REPORT TO THE DEVELOPMENT PERMIT BOARD

Subject: File # DP 22002 Lot 6, Wesbrook Place
Market Residential Project – The Wordsworth

WORDSWORTH

Revised Development Permit Submission
February 25, 2022

PARTIAL SECTION B-B (HEIGHT VARIANCE REQUEST)
1/16"=1'-0"

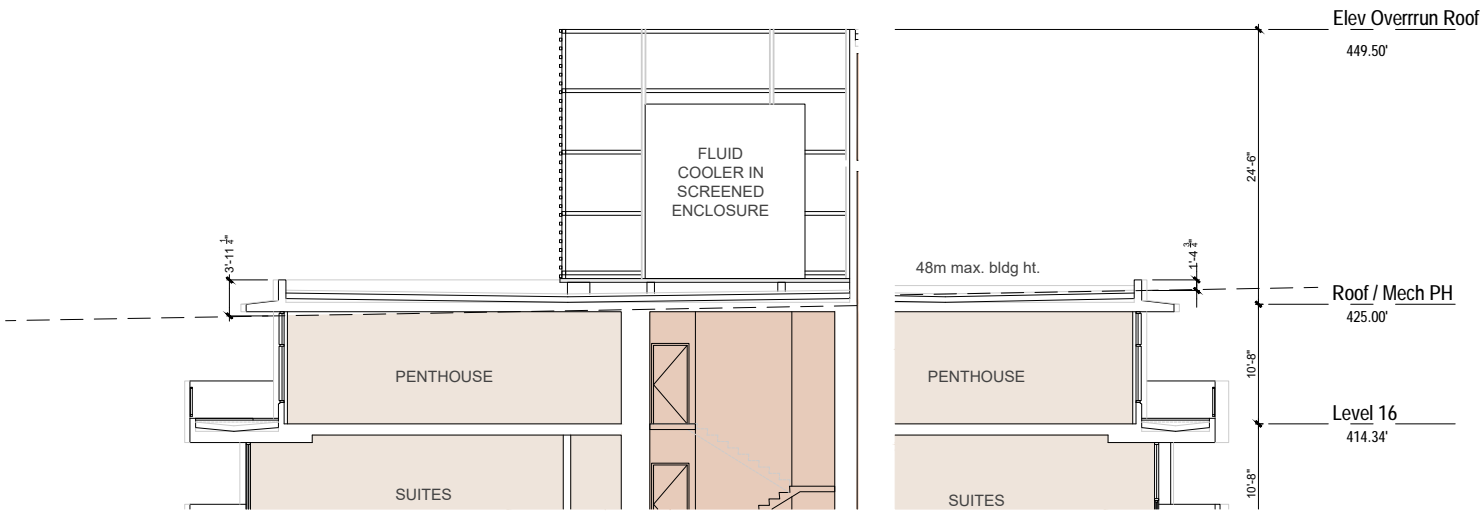
The applicant is requesting a variance to the maximum permitted height of the high rise apartment building. The maximum height permitted for this parcel is regulated in two ways: by the number of storeys (maximum 16 storeys as designated for this site in Map P-10 of the Wesbrook Neighbourhood Plan) and by a height measurement as described in the Development Handbook for this Development Area (48.0 metres as noted in Sec. SC3C.5 d). The variance requested is for an additional 1.37 meter projection of the northern section of the roof beyond the 48.0 meter maximum. Although the building complies with the maximum number of storeys permitted in the Neighbourhood Plan, a variance to the maximum measured height regulation in the Development Handbook is required.

Because the site slopes approximately 3.57 meters from north to south and to a lesser extent across the site, the applicant team is requesting this variance in order to position the lobby entrance at grade. As a result, a portion of the northern edge of the highrise roof extends 1.37 above the 48.0 metre height maximum. This height variance was supported by the Advisory Urban Design Panel and by staff in order to allow the entrance to be accessible and strengthen the relationship of the main floor activities to the exterior public realm.

Variance Request
Request height variance of up to 4’-6” due to slope across the site and height calculation based on sloped base plane method of calculation. Refer to sections on page 33. We note, the ground level of the 16 storey tower is set for accessible entry at the lobby, and is recessed below grade approximately 2’-0” at the north end of the tower.
